Model Error Resolution Document

1. Originator: Ernest Hardin	2. Date: 03/18/2008	3. ERD No. ANL-EBS-MD-000033 ERD 01
4. Document Identifier: ANL-EBS-MD-000033 REV 06	5. Document Title: Engineered Barrier System: Physical and Chemical Environment

Figure 6.3-5. Representative Repository Drift Locations Selected for the NFC Model

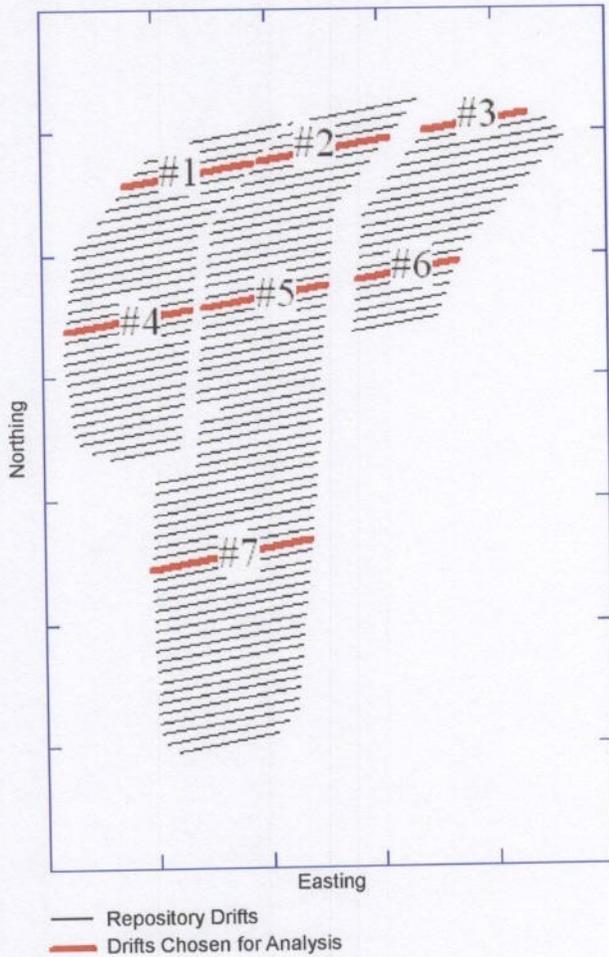
4.) Figure 6.3-5: Changed as follows (Note that it was noticed that the figure was an old figure and is being corrected here as well):

NOTE: Drifts defined on the basis of waste package end-point coordinates in SNL 2007 [DIRS 179466], Table 4-1, Parameter Number 01-01.
